# SR 92 REALIGNMENT AND WIDENING

## Value Engineering Study Report

Preliminary Design Stage

May 2008

ALTERNATIVE No.  
HA-R-3A  
ORIGINAL DESIGN  
SHEET 2 OF 5

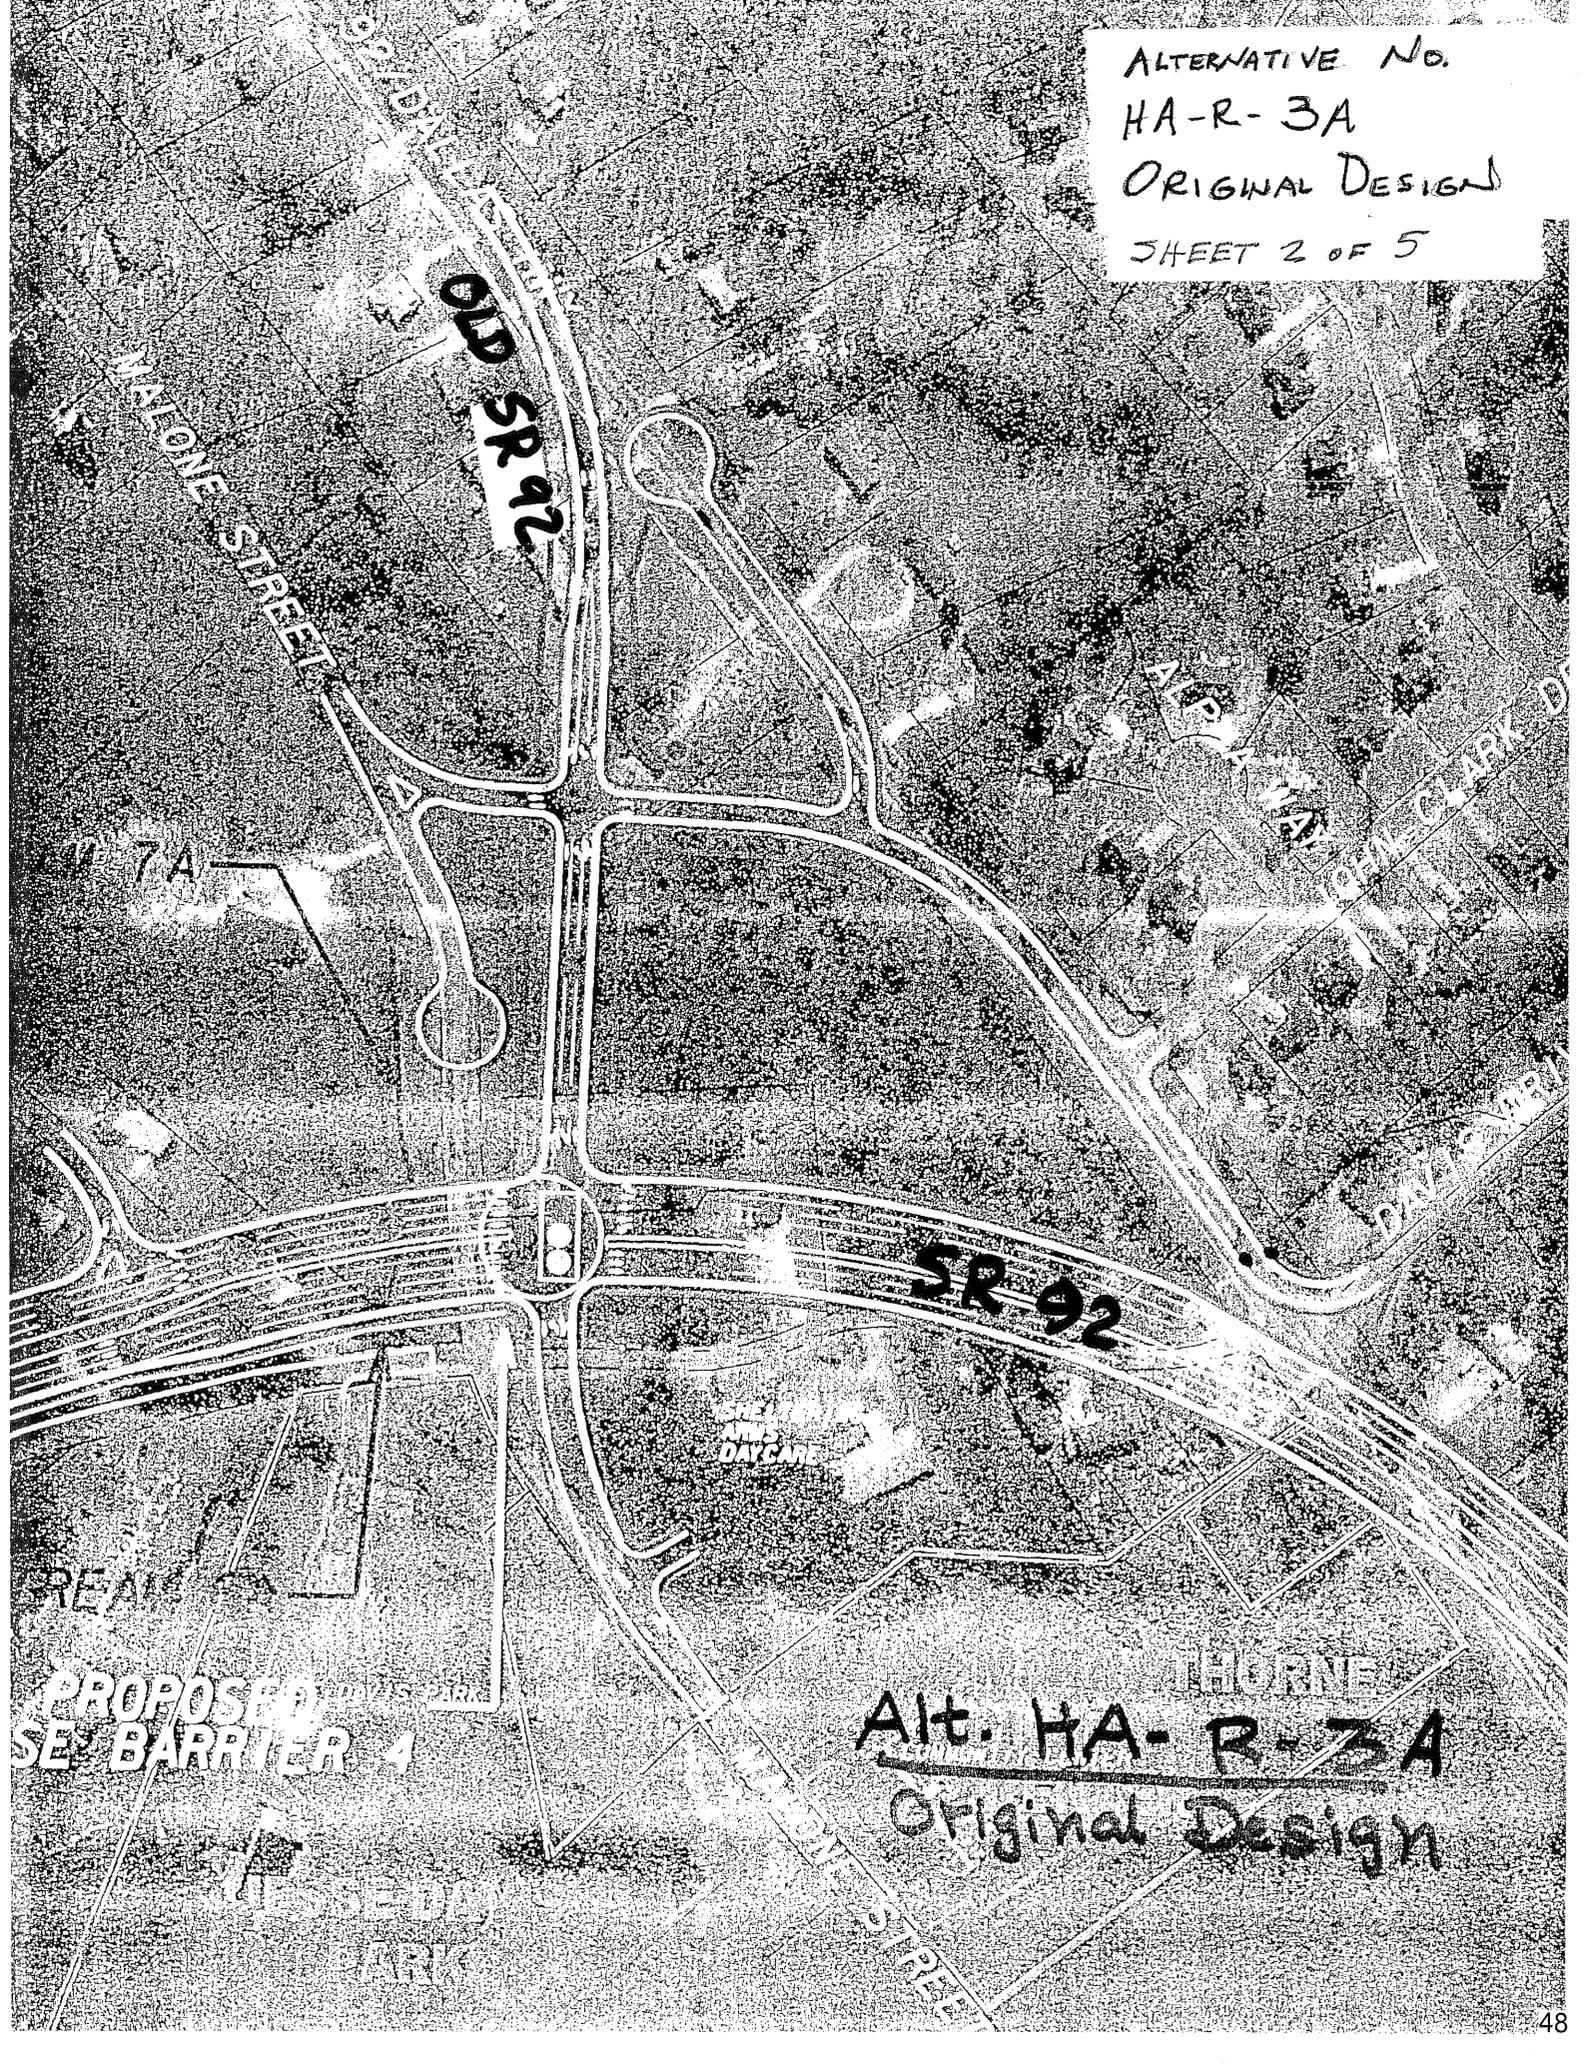
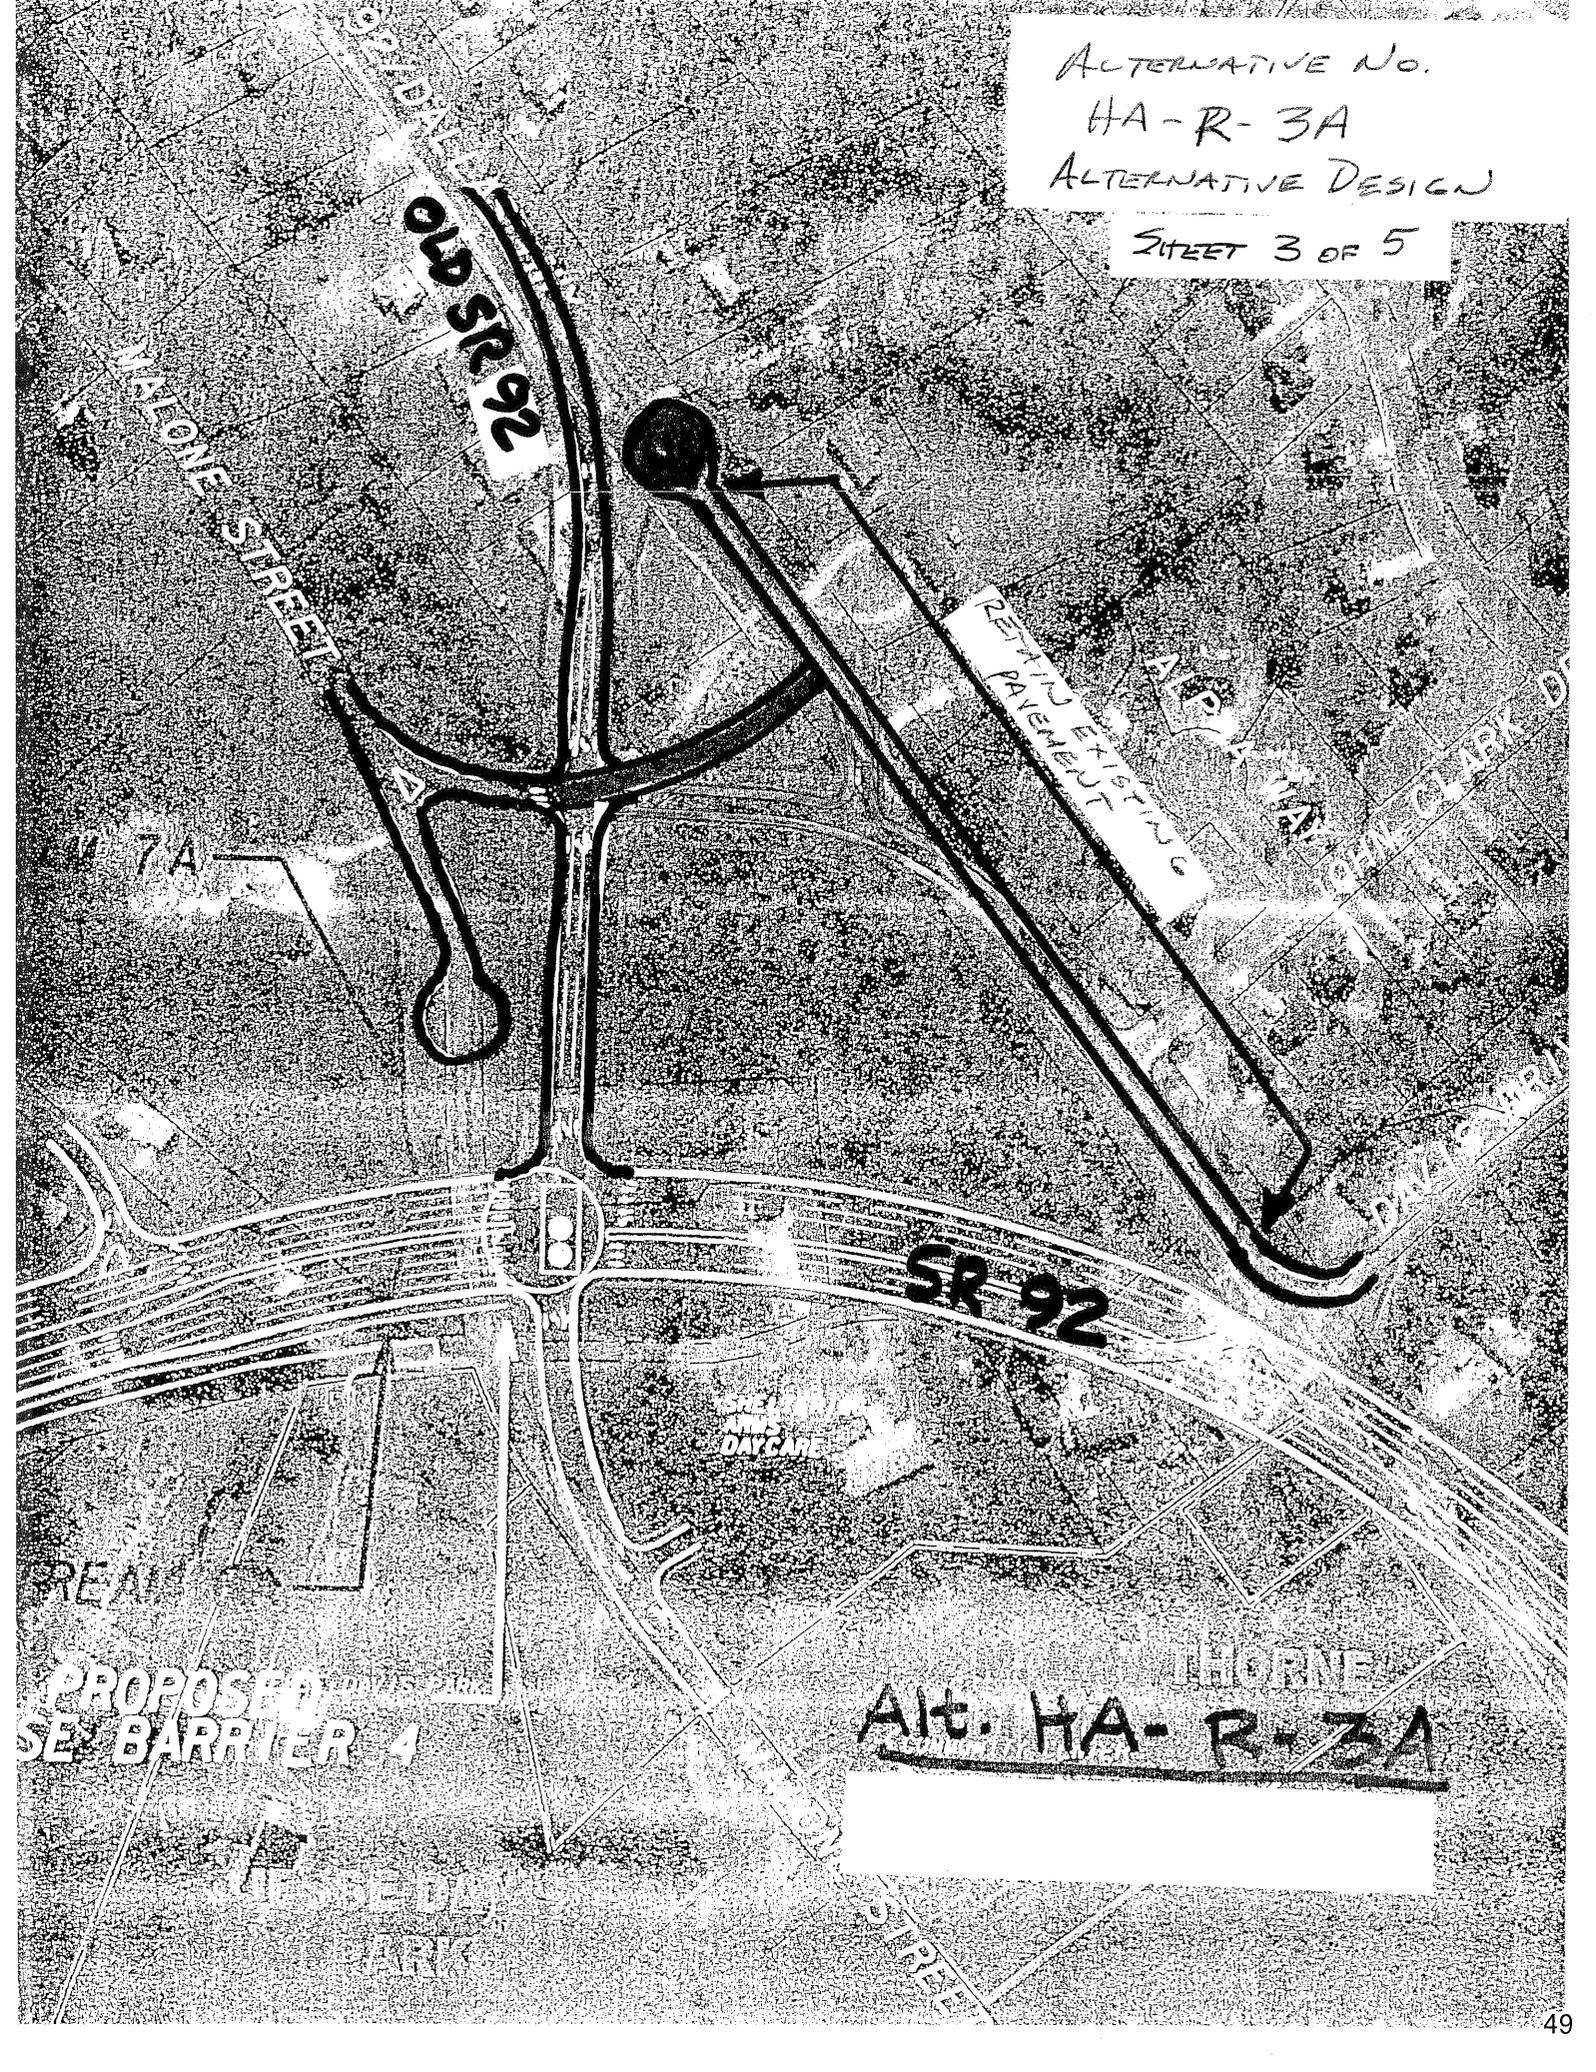
- Reduces cost
- Minimizes disruptions to existing roadway network
- Accelerates construction
- Reduces right-of-way impacts

- Modifies NEPA footprint

ALTERNATIVE NO.  
HA-R-3A  
ALTERNATIVE DESIGN

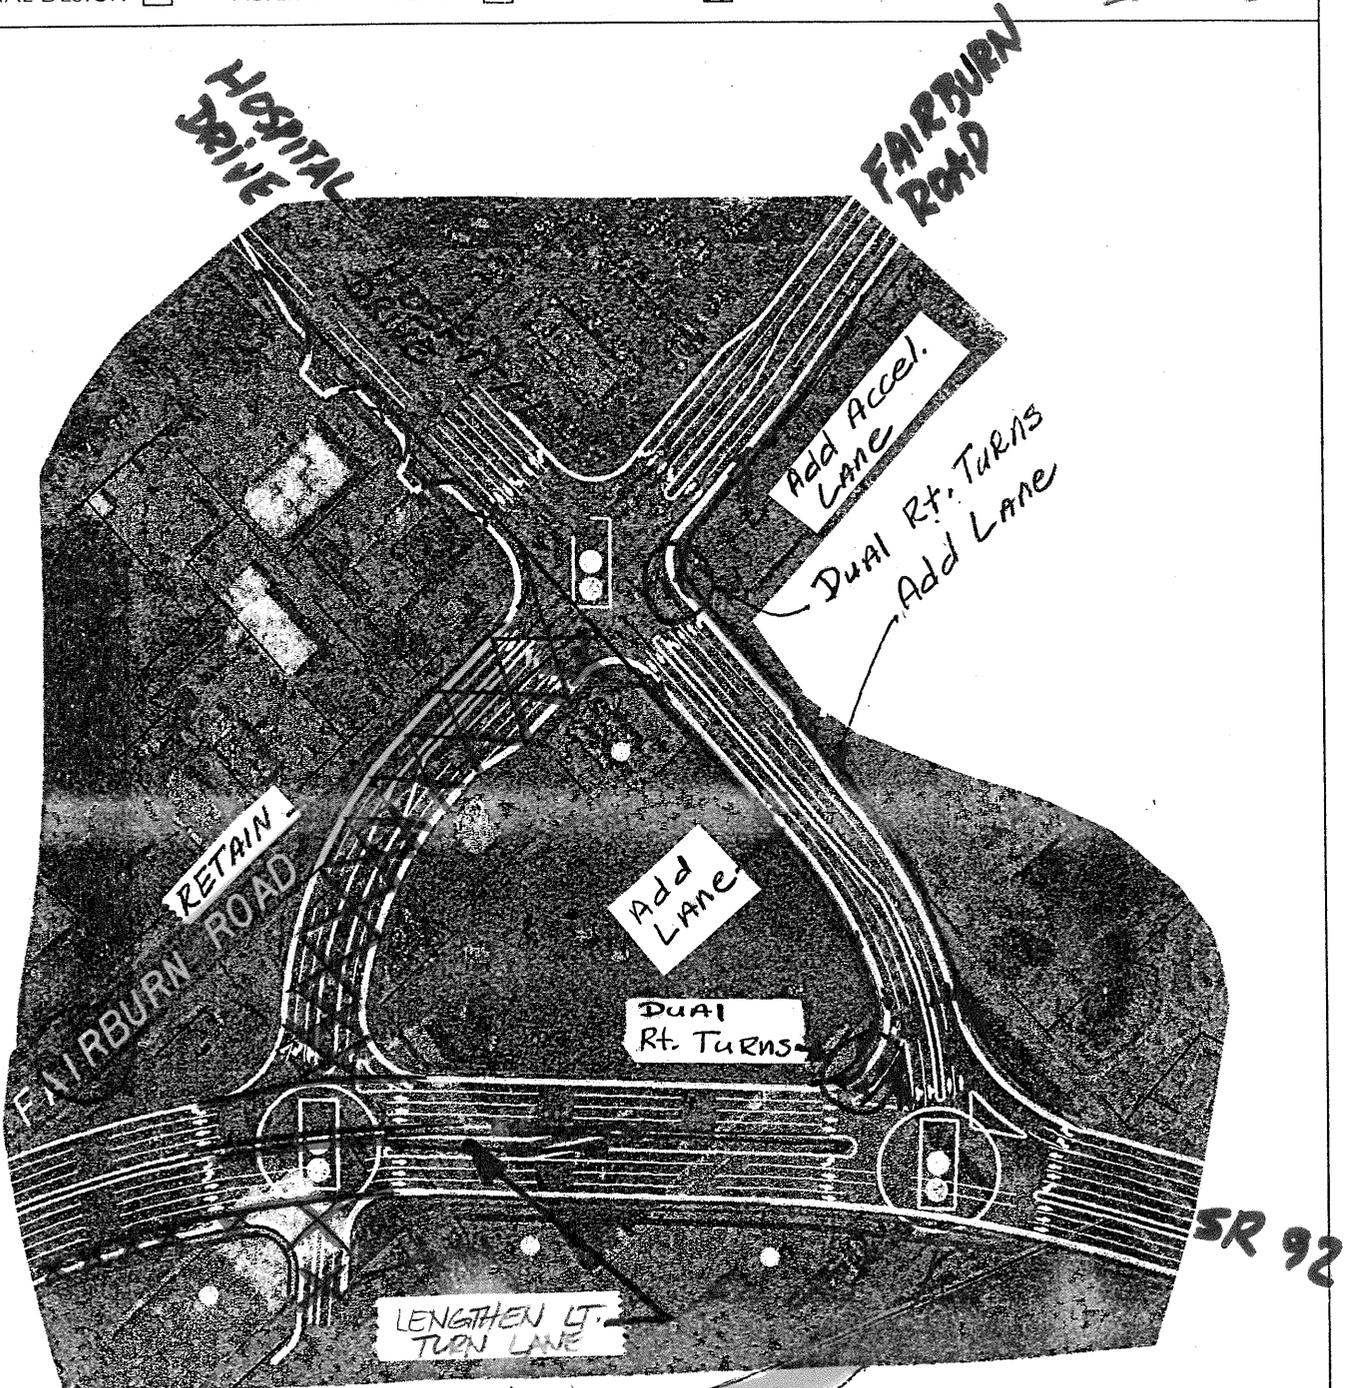
Connect only Hospital Drive to SR 92 and create a cul-de-sac on Fairburn Road in lieu of the proposed connection to SR 92. Add lanes in both directions of Holiday Drive between SR 92/Fairburn Road. Extend the northbound SR 92 left turn at Hospital Drive as needed (no longer constrained by the Fairburn Road/SR 92 intersection). Relocate the access to the school opposite Hospital Drive.

The intent is to keep Exist. Fairburn Rd. As a "Drive" to Exist. Businesses.
